E SERIES PROPORTIONAL PRESSURE CONTROLS

Pilot Relief / Relief / Reducing and Relieving

**PROPORTIONAL
CONTROLS**

Interchangeability between Current and New**■ Interchangeability between Current and New Design**

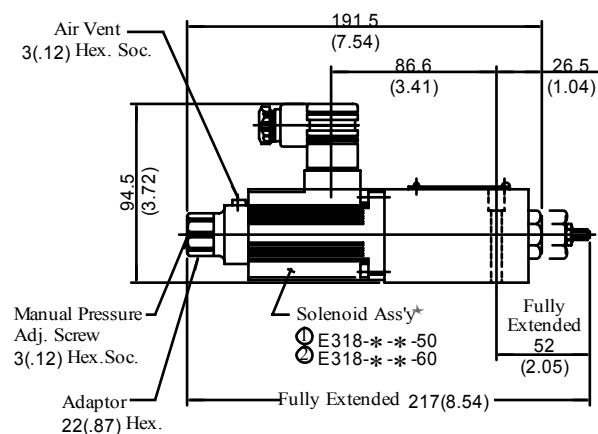
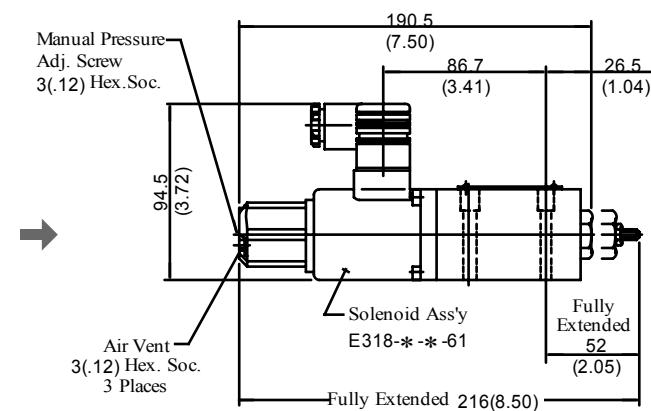
EDG-01 series valve has changed model from 50 to 51 design in line with the solenoid improvement.

There is an interchangeability in the mounting dimensions, however, the outside shape and dimensions are changed as shown below due to solenoid improvement and other modifications.

★The solenoid assembly current design comes in two types① E318-50 design and② 60 design.
See the figure on the left for an external view of type① . See the figure on the right for type② .

Current: Design 50**New: Design 51**

■ Interchangeability between Current and New Design

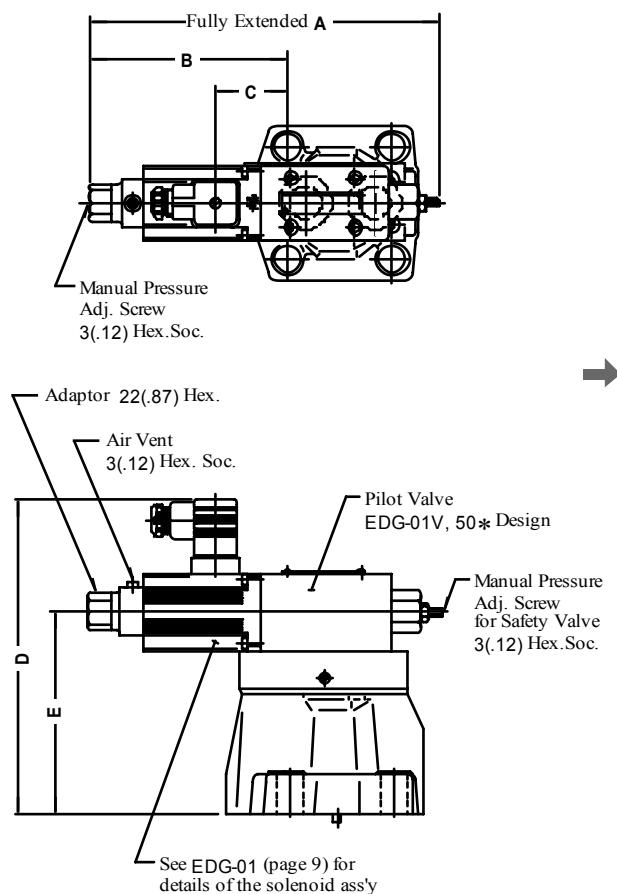
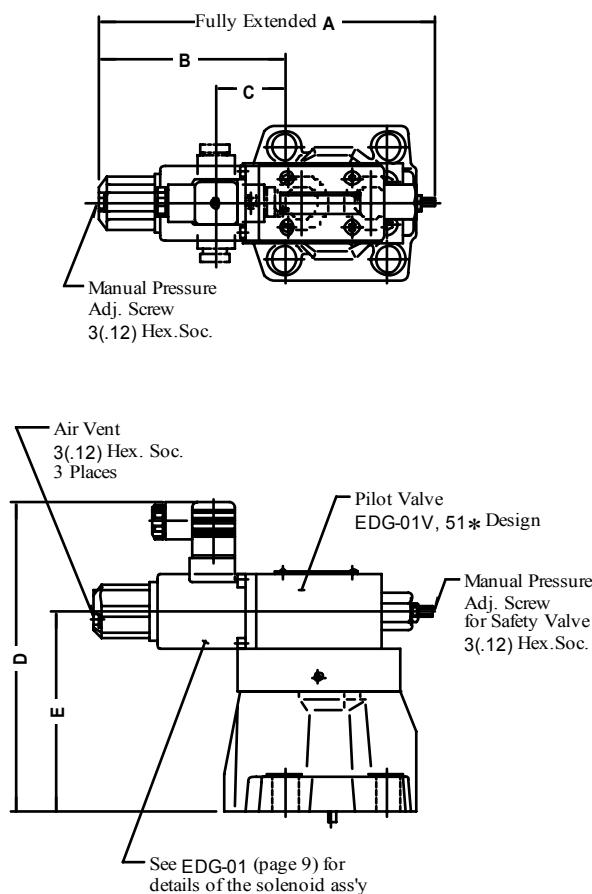
EBG-03/06/10 series valves have changed model from 50 to 51 design in line with the model change of pilot valve (EDG-01).

There is an interchangeability in the mounting dimensions, however, the outside shape and dimensions are changed as shown below due to pilot valve improvement and other modifications.

Model Numbers		A	B	C	D	E
Current	EBG-03-**-50/5090	217 (8.54)	118.6 (4.67)	40.2 (1.58)	199.5 (7.85)	130 (5.12)
New	EBG-03-**-51/5190	216 (8.50)	117.6 (4.63)	40.3 (1.59)		
Current	EBG-06-**-50/5090	217 (8.54)	120.5 (4.74)	42.1 (1.66)	199.5 (7.85)	130 (5.12)
New	EBG-06-**-51/5190	216 (8.50)	119.5 (4.70)	42.2 (1.66)		
Current	EBG-10-**-50/5090	217 (8.54)	102 (4.02)	23.6 (.93)	235.5 (9.27)	166 (6.54)
New	EBG-10-**-51/5190	216 (8.50)	101 (3.98)	23.7 (.93)

Interchangeability between Current and New
■ Interchangeability between Current and New Design

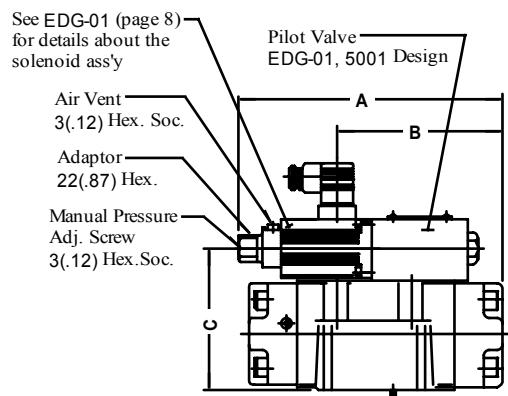
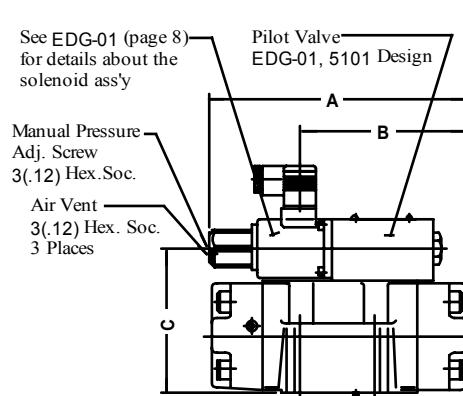
ERBG-06/10 series valves have changed model from 50 to 51 design in line with the model change of pilot valve (EDG-01).

There is an interchangeability in the mounting dimensions, however, the outside shape and dimensions are changed as shown below due to pilot valve improvement and other modifications.

Model Numbers	A	B	C
Current ERBG-06-*50/5090	214.5 (8.44)	136.5 (5.37)	115 (4.53)
New ERBG-06-*51/5190	213.5 (8.41)	136.5 (5.37)	115 (4.53)
Current ERBG-10-*50/5090	235.5 (9.27)	158 (6.22)	117 (4.61)
New ERBG-10-*51/5190	234.5 (9.23)	158 (6.22)	117 (4.61)
